From: p.whitley - [REDACTED]
Sent: 17 January 2021 19:58
To: Hazelton, Laura
Cc: [REDACTED] Patricia Thomas
Subject: OBJECTION : 2020/5850/L and 2020/5789/A Terrace Around First Floor Horse Hospital, Stables Market

7.7 IMPRESSION FROM CORNER OF CHALK FARM ROAD

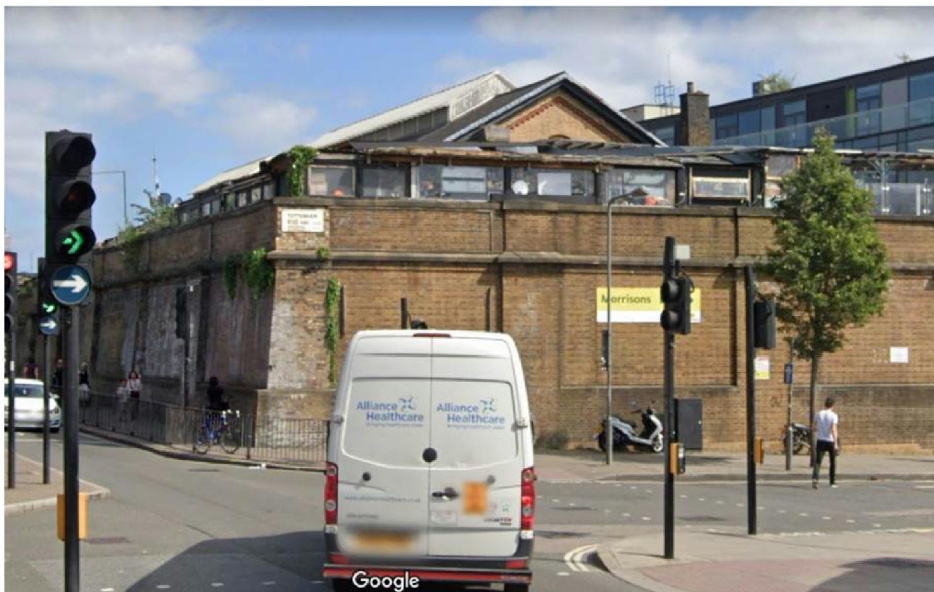
At present, there are tacky makeshift stalls surrounding the face of this magnificent tribute to our industrial heritage, but at least one can see the top part of the main building.

This proposal would completely obscure the main building, and make permanent the harm to its heritage quality that are caused by the temporary stall structures. This complete obscuring would cause substantial harm to the setting of this grade II* structure, which harm is not offset by any public benefit from the development.
